CHRIS TEAM SUBDIVISION

FINAL DRAINAGE REPORT

EL PASO COUNTY PROJECT NO: SF246

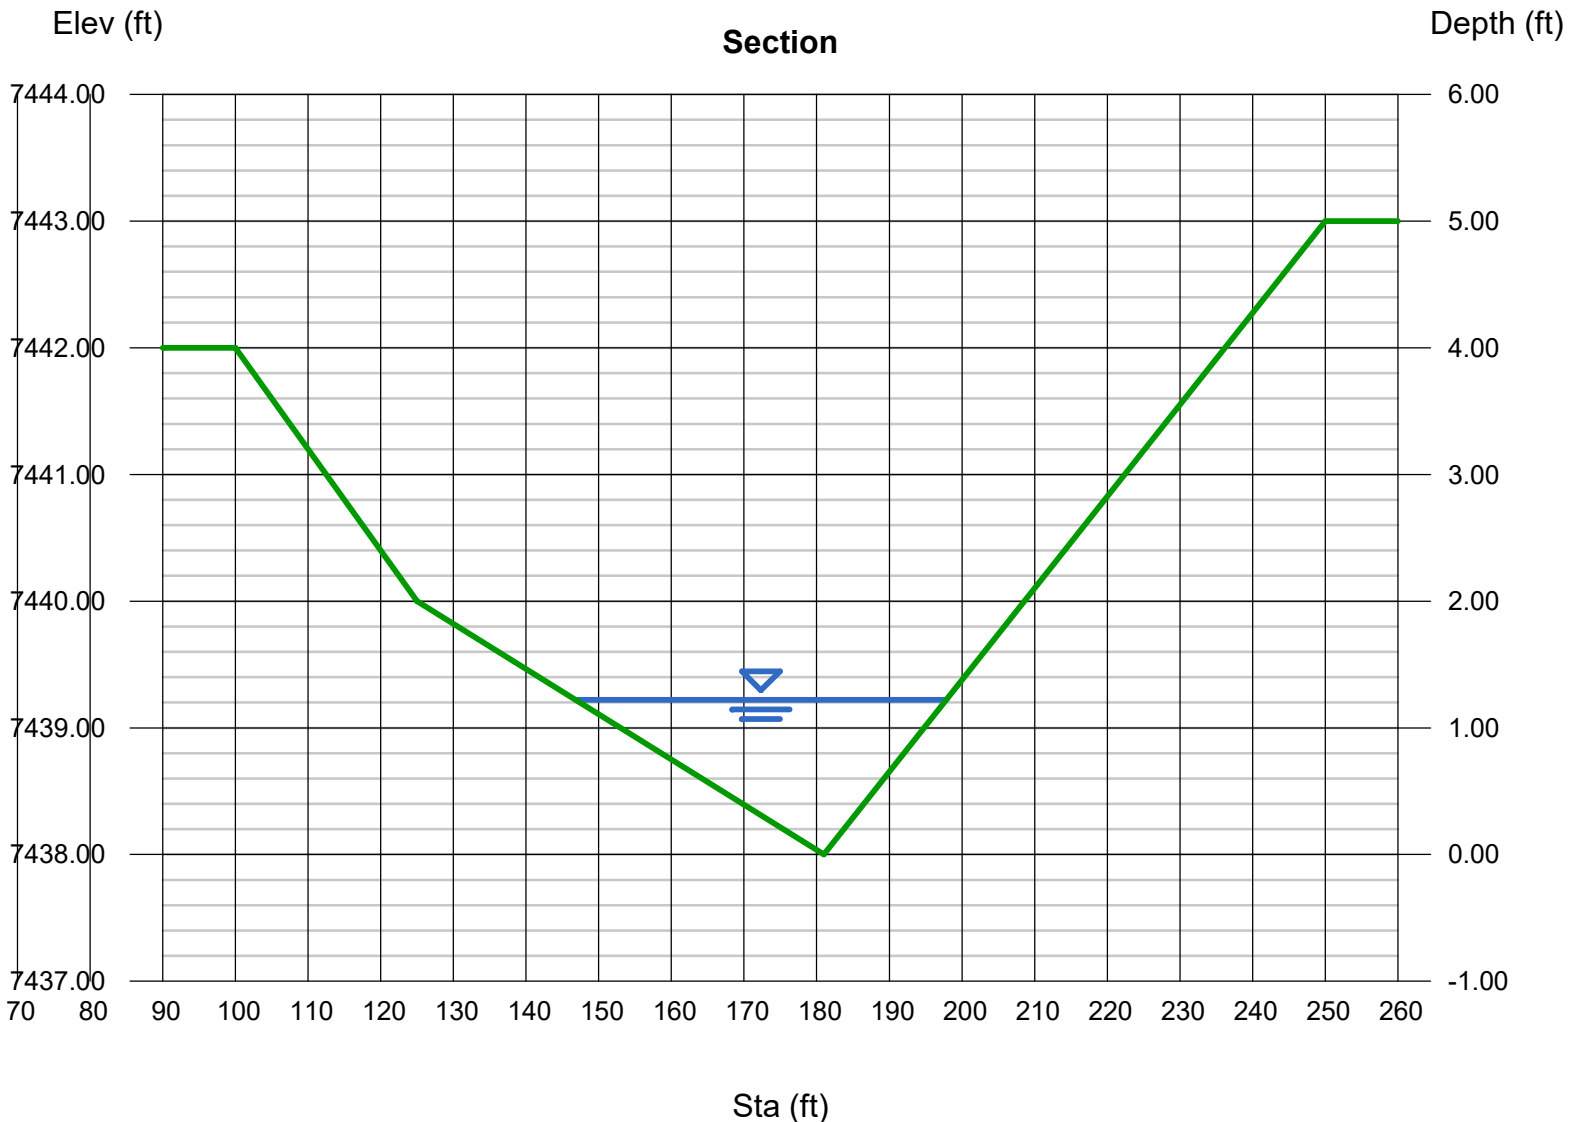
Please correct page orientation.

Ex Culvert #2

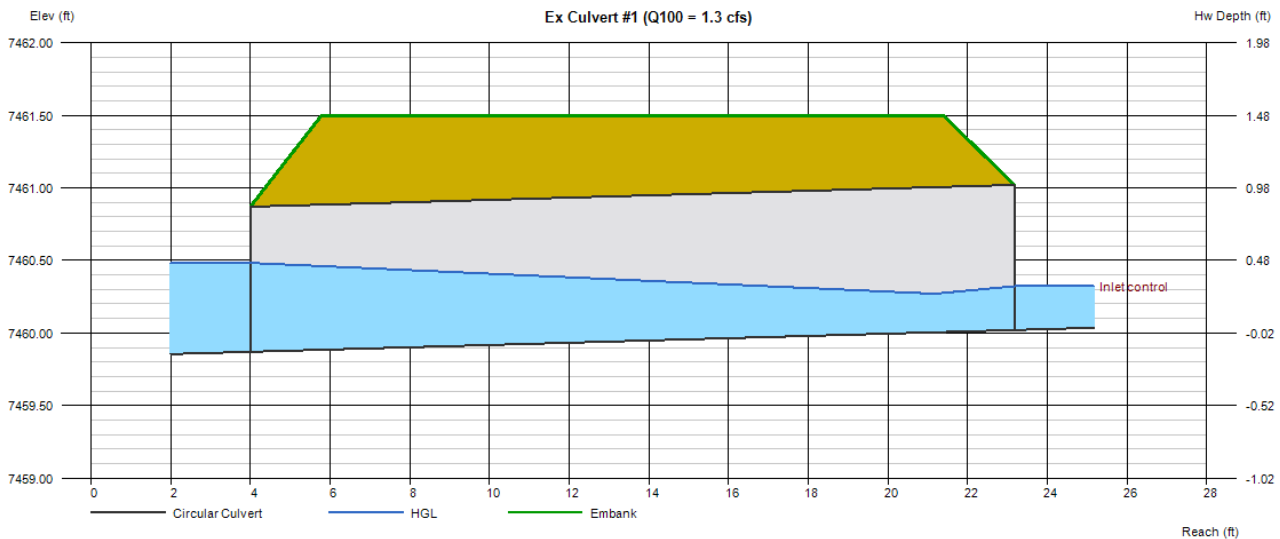
How was flow determined for this culvert? Provide discussion of this culvert in report

EXISTING CONDITIONS DRAINAGE MAP

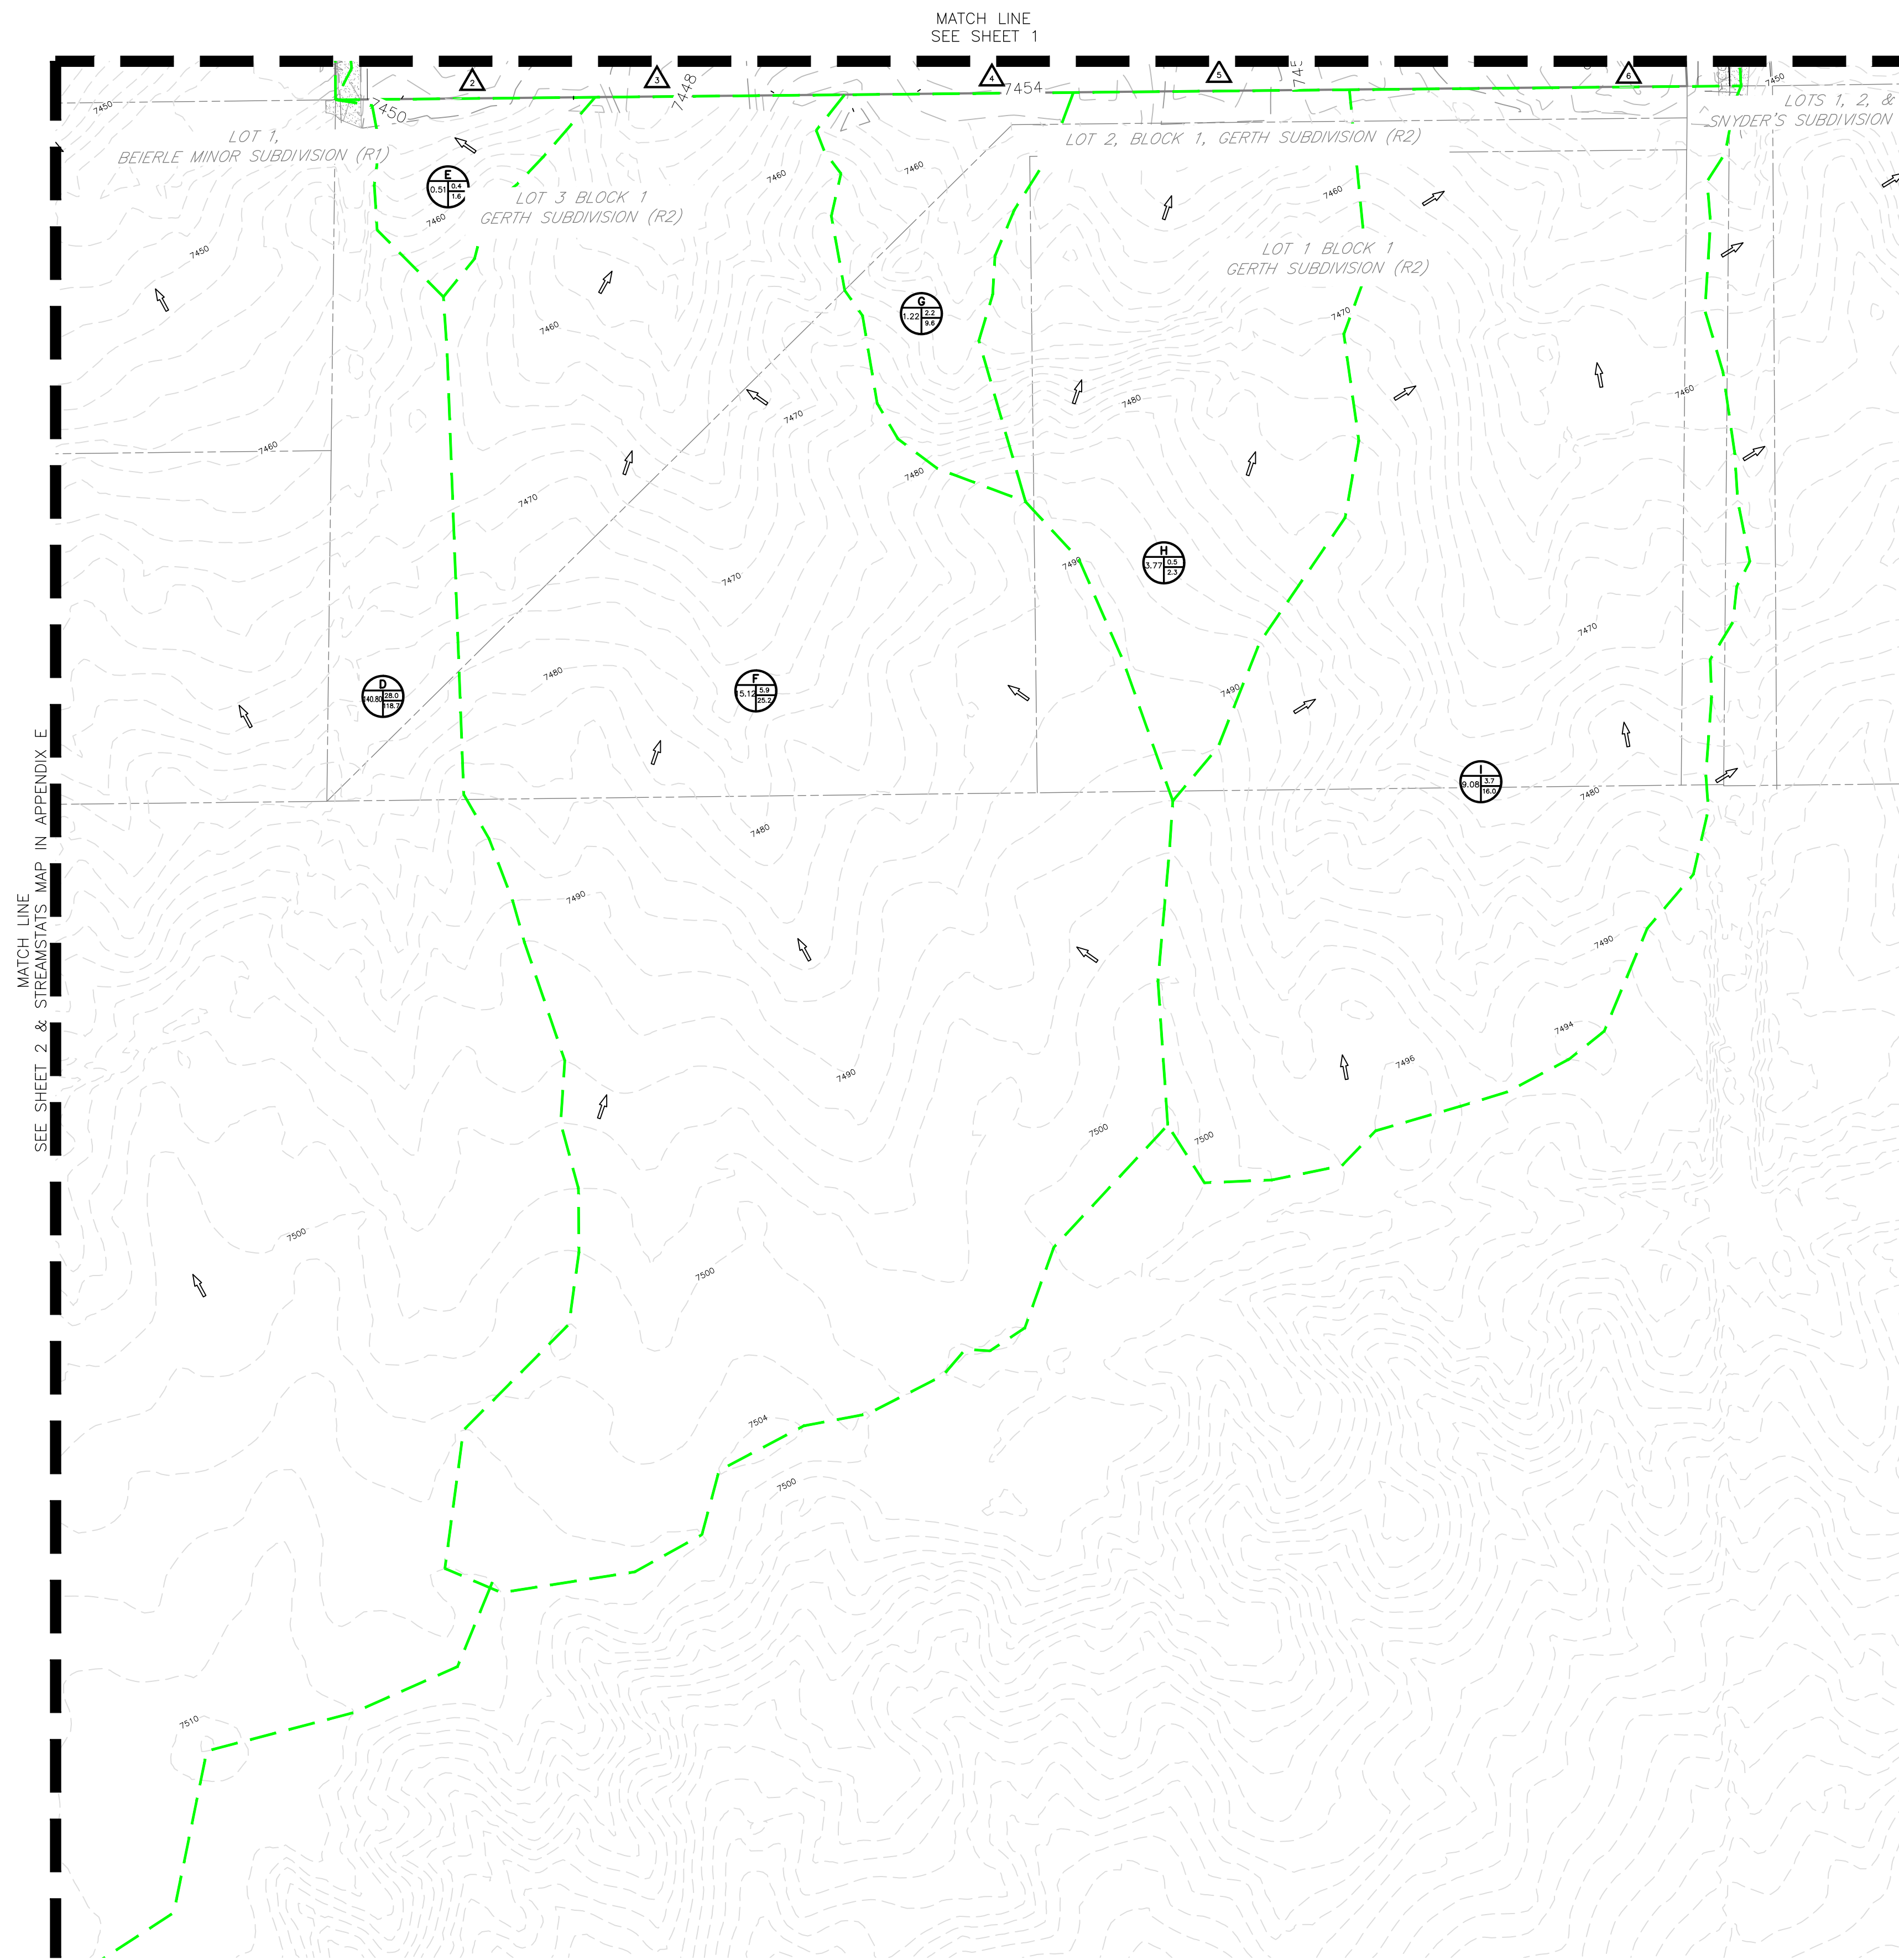
Basin should be separated at the drainage easement line with design points. These design points can then be added into the channel flow to result in a total flow outfalling offsite at DP7.

EXISTING CONDITIONS DRAINAGE MAP	
CHRIS TEAM SUBDIVISION	
JOB NO: 24019	SHEET
LOCATION: EPC	2
11/29/2024

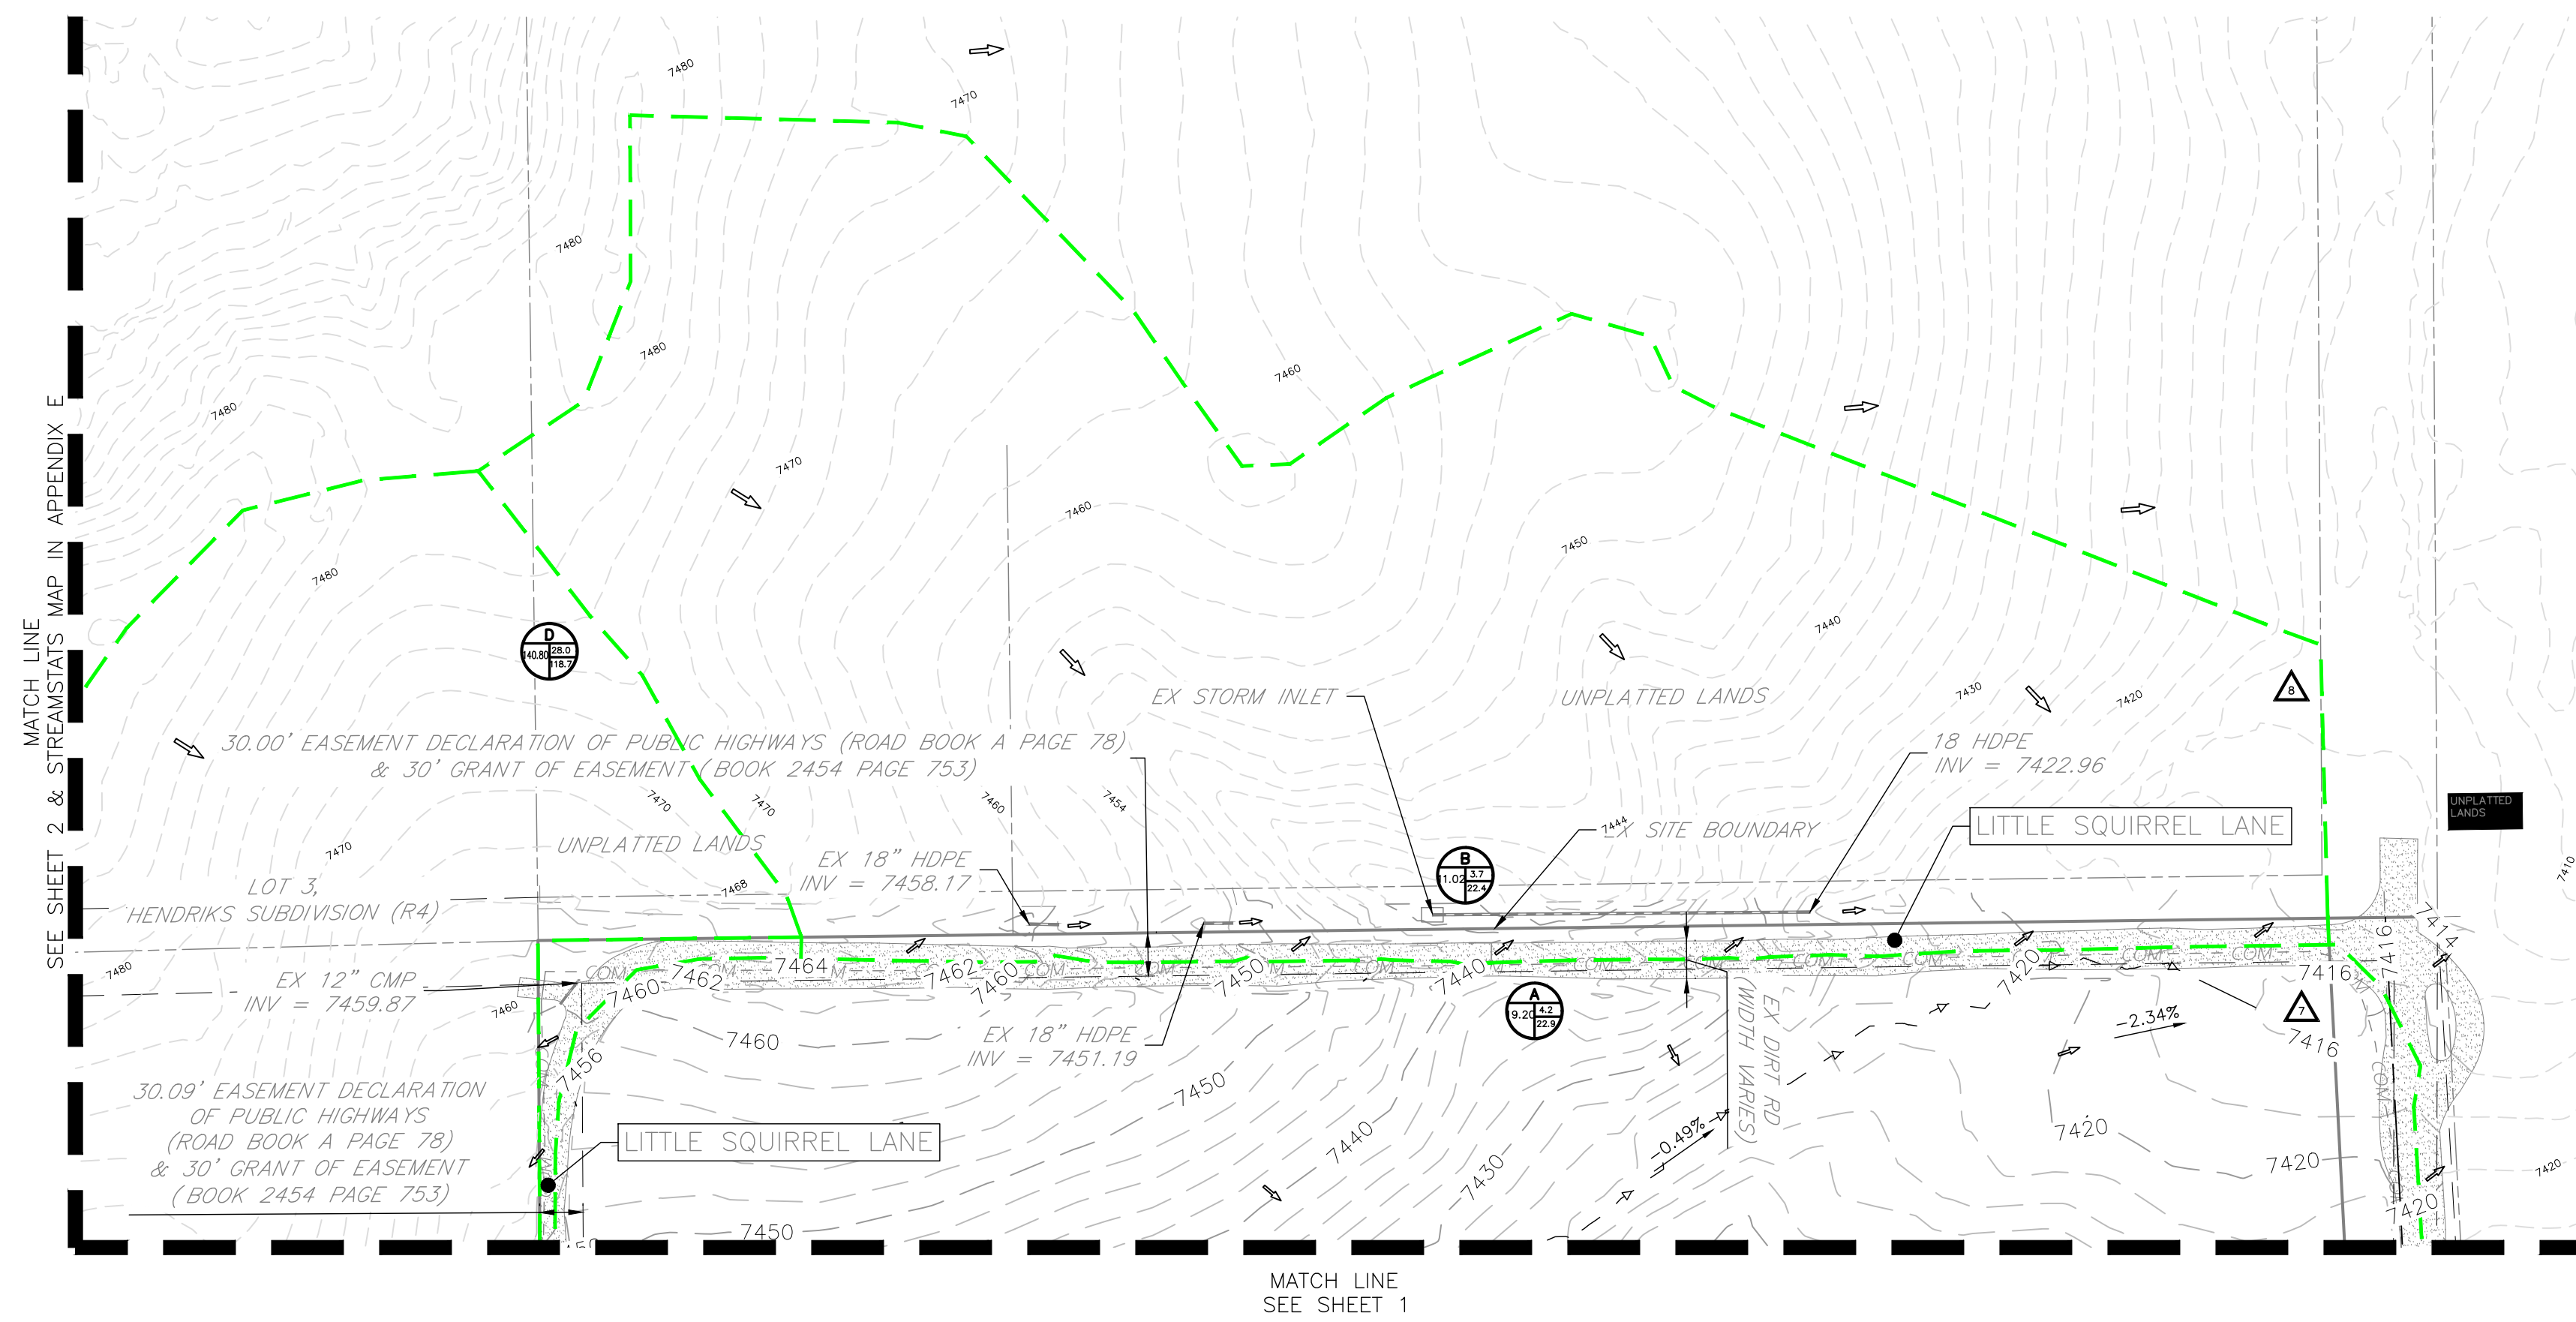
Sheet 3 please, for clarity.
